UNITED STATES PATENT AND TRADEMARK OFFICE

10/796,487

Office Action Summary	Application No. 10/796,487	Applicant(s) UEDA, YUICHI	
	Examiner Gregory W. Adams	Art Unit 3652

DETAILED ACTION***Claim Objections***

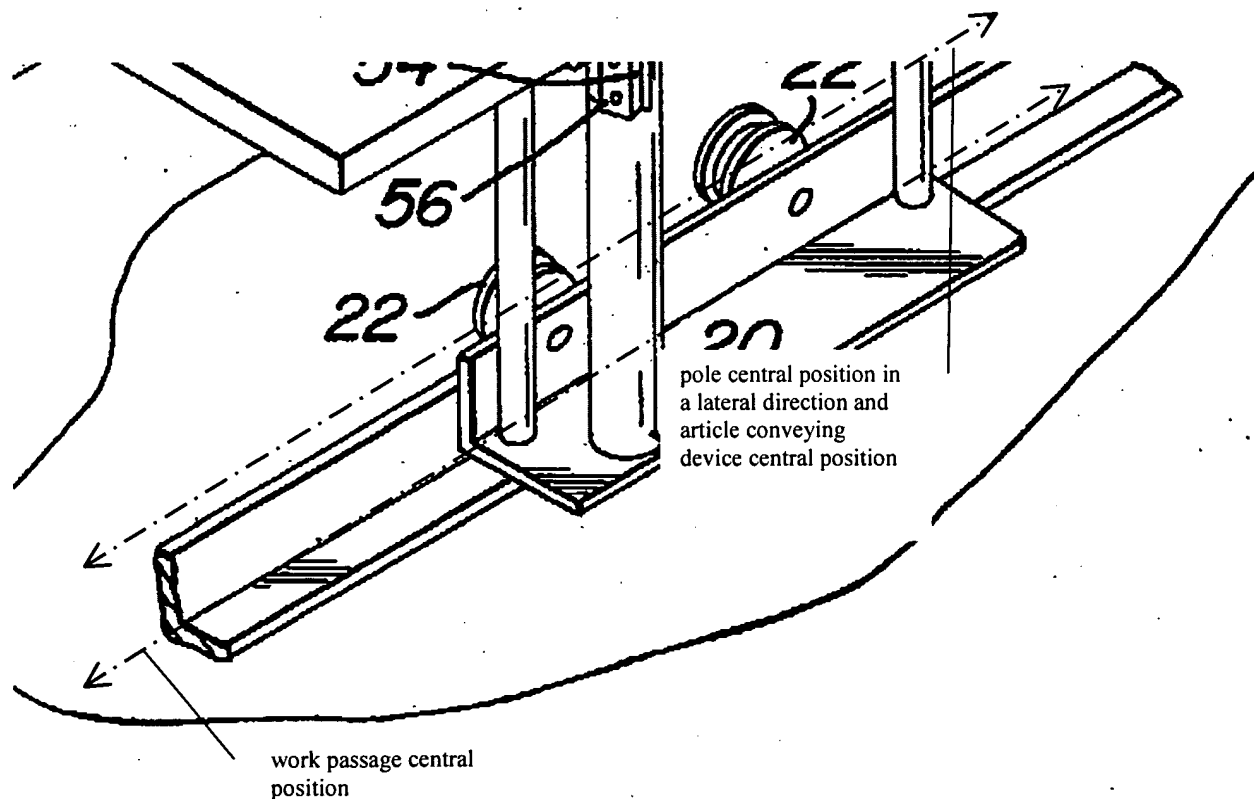
poles to a truck body vertical side. It is noted that "central position" is a relative term. A line that runs through the center of Browns poles 22 is a center line as it runs through the center of the poles. This is also the center line of the apparatus as a whole as the apparatus comprises the poles 22. And where ever the apparatus operates is inherently a work passage. Thus, the center line of the apparatus is inherently in the exact position as the center of the work passage. See figure below.

It is noted that "central position" is a relative term. Without a frame of reference any line is a center line. A line that runs through the center of Browns poles 22 is a center line as it runs through the center of the poles. This is also the center line of the apparatus as a whole as the apparatus comprises the poles 22. And Brown's apparatus operates inherently in a work passage where the work passage is configured to place the poles 22 at the work passage center. The apparatus travels along the work passage. Thus, the center line of the apparatus is inherently in the exact center of the work passage.
